Re: Final Subdivision Plat Approval
2, 4 & 6 Massaro Court

Re: Final Subdivision Plat Approval
2, 4, & 6 Massaro Court

Below is a response letter affirming that the approval conditions listed on the May 8, 2023, Planning Board resolution will be completed to the satisfaction of the Planning Board as required for final subdivision approval of the 3-lot subdivision at 2, 4, & 6 Massaro Court:

FINAL
LOT LINE ADJUSTMENT PLAT
PREPARED FOR
BERNARDO LUCIANO
AND
FILOMENA LUCIANO
SITUATE IN THE
TOWN OF NORTH CASTLE
WESTCHESTER COUNTY, NEW YORK

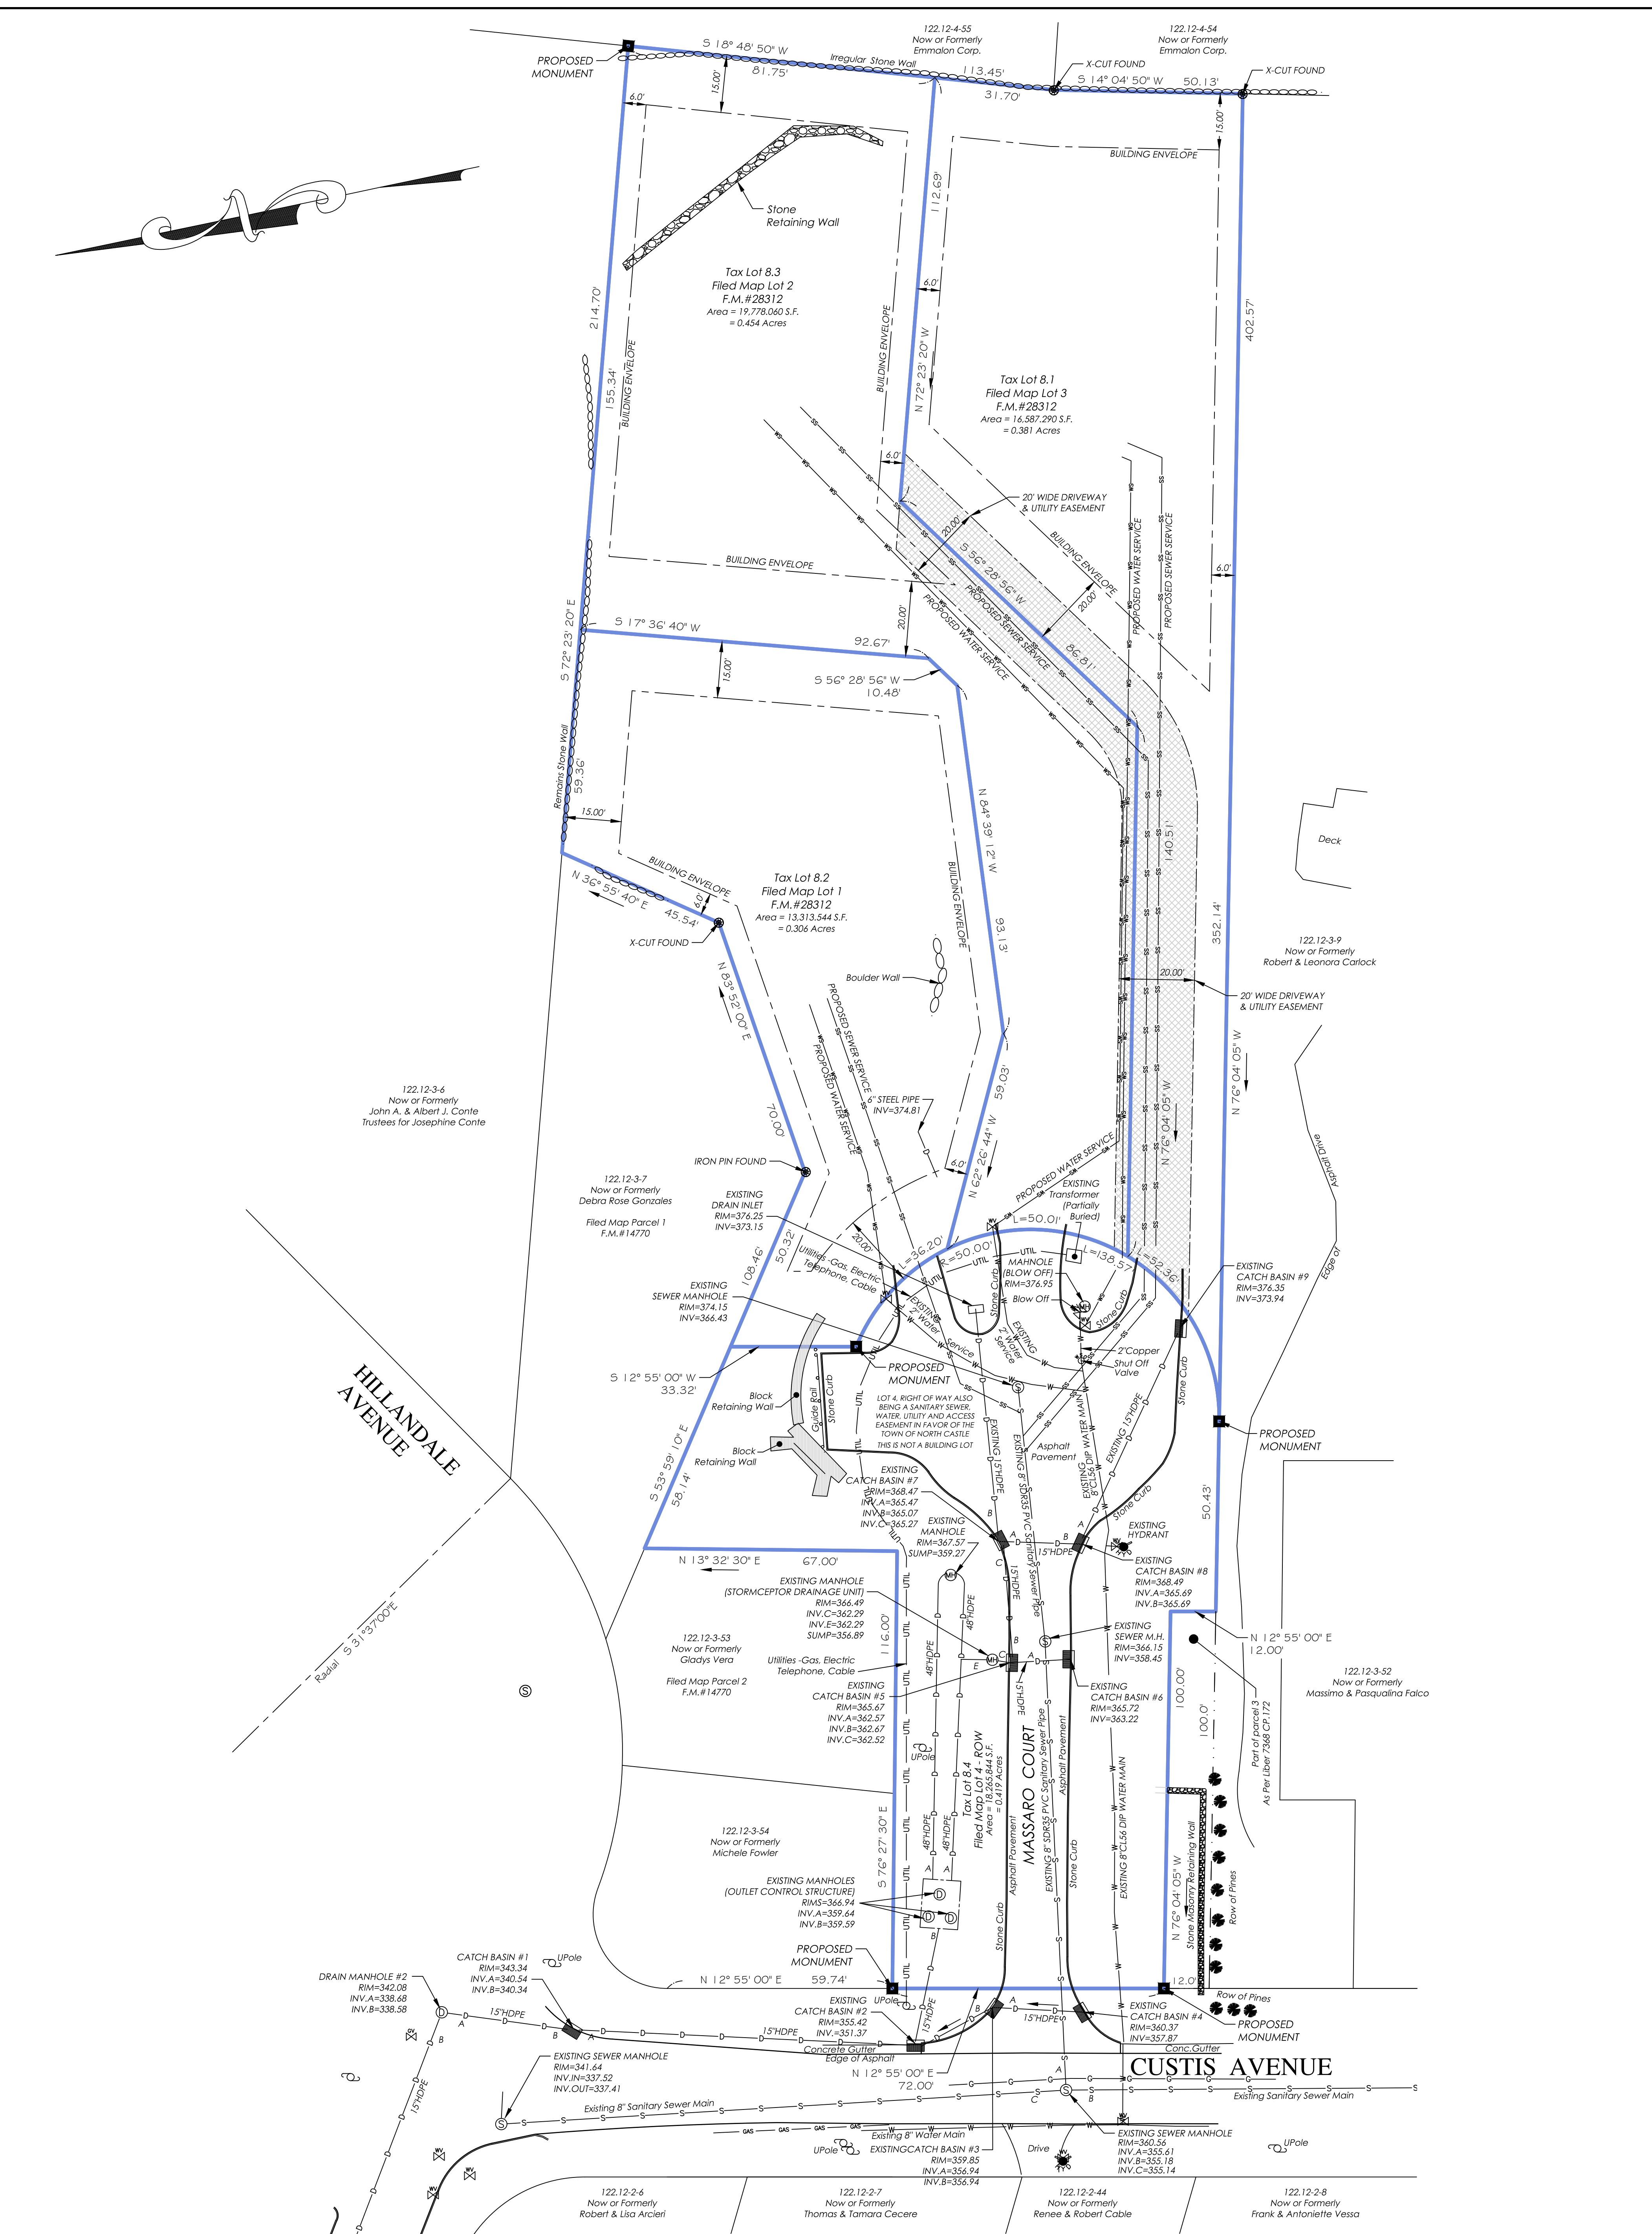
1. The plat shall be revised to contain a note, to the satisfaction of the Planning Department, stating that "Planning Board site plan approval shall be required for all lots in this subdivision."
To be completed by TC Merritts Land Surveyor.

- Notes:
- All water service connections will be sized to accommodate 2 family residential fire sprinkler systems.
 - Lot number 4 is a Right of Way.
 - An easement is hereby granted over the whole of Lot number 4, to the Town of North Castle for operation and maintenance of the public water and public sanitary sewer systems.
 - Lot number 4 shall contain a private road that is not to be offered for dedication to the Town of North Castle.
 - The size of the water service connection to each lot shall be determined when the property owner applies for a building permit for that lot.
 - Permanent easements over Lot 4 are granted to Lots 1, 2 and 3 for sanitary sewer, water supply, storm drainages, electric, gas, telephone, cable television and any other utilities.
 - Planning Board site plan approval shall be required for all lots in this subdivision.
